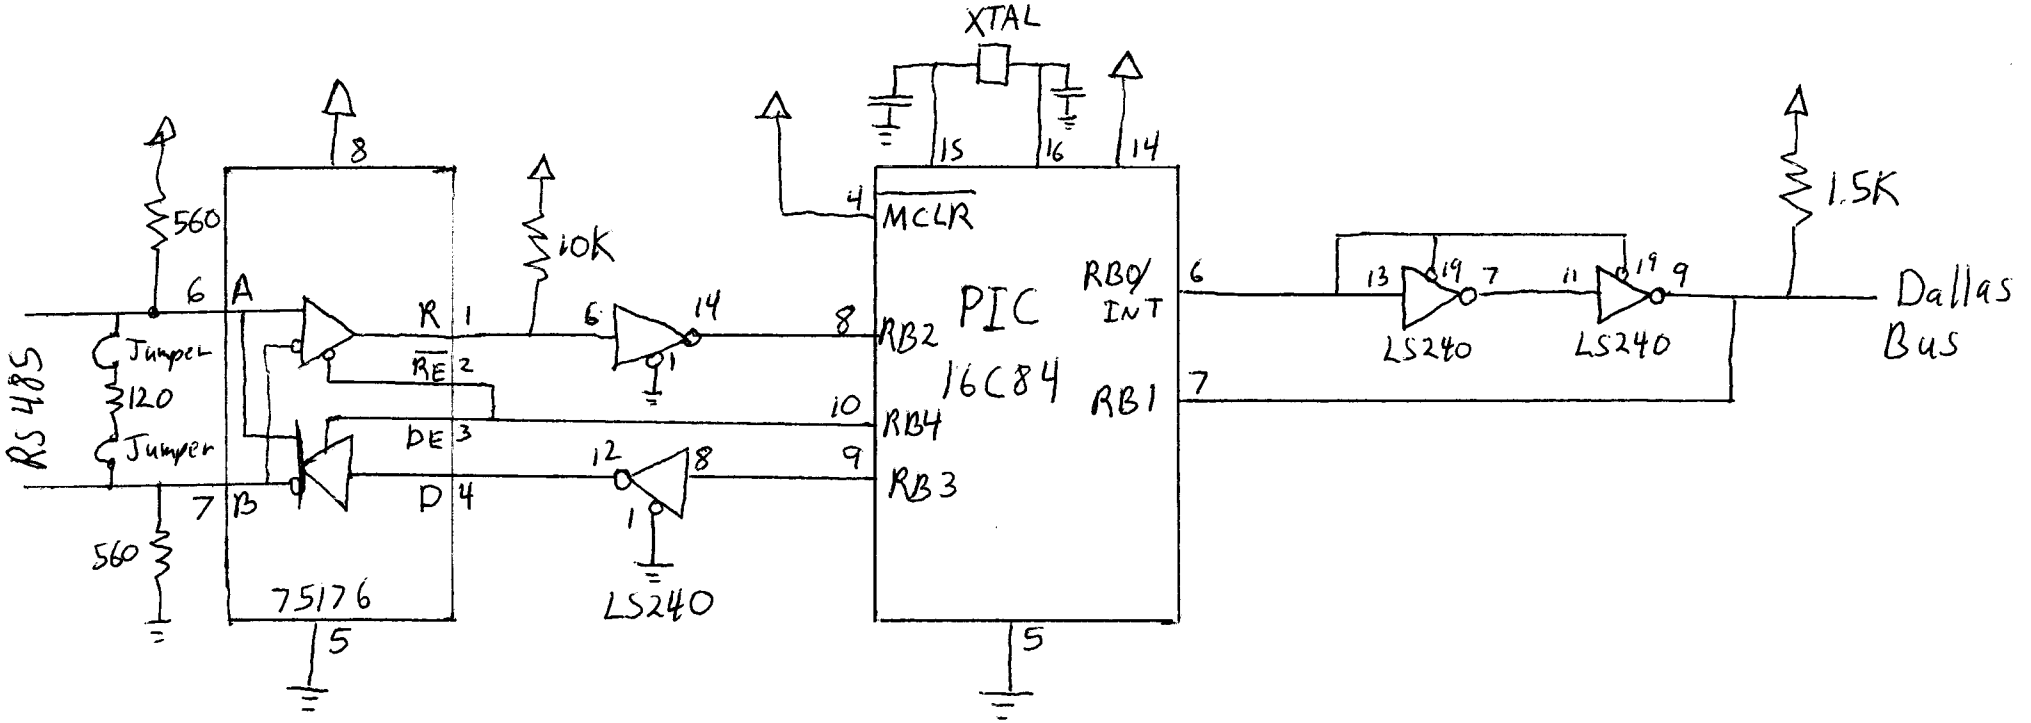
Note: On present board (2/18/98)
560 resistors are interchanged
(A goes to ground; B to V_{cc})
